# HARTING Product Change Notification

Business Unit: HARTING Electric GmbH & Co. KG PCN/0036

Title: Han-Modular® Compact Carrier Hood &

Han-Modular® Compact Bulkhead Mounting Housing

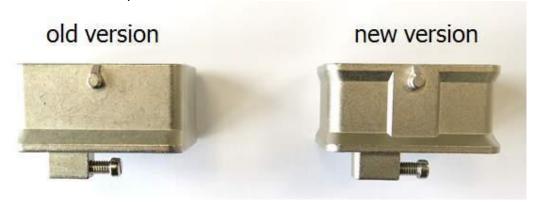
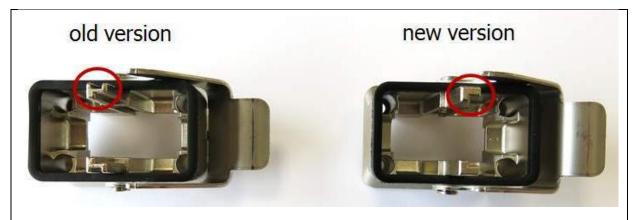
The designs of the Han-Modular® Compact Carrier Hood 09 14 001 0311 and the Han-Modular® Compact Bulkhead Mounting Housing 09 14 001 0301 have been changed

- The new design has the main advantage of weight reduction as the amount of material is reduced. The weight reduction for both individual parts is approx. 18 g.
- The fixing of the flange gasket is improved as it is stabilized in the hood. This
  modification ensures easier handling.
- All other mechanical and electrical characteristics remain the same. The parts are
   100 % mating compatible. Also prices remain the same.

The revision level of the Han-Modular® Compact Carrier Hood 09 14 001 0311 has been changed from 01 to 02.

The revision level of the Han-Modular® Compact Bulkhead Mounting Housing 0914 001 0301 has been changed from 02 to 03.
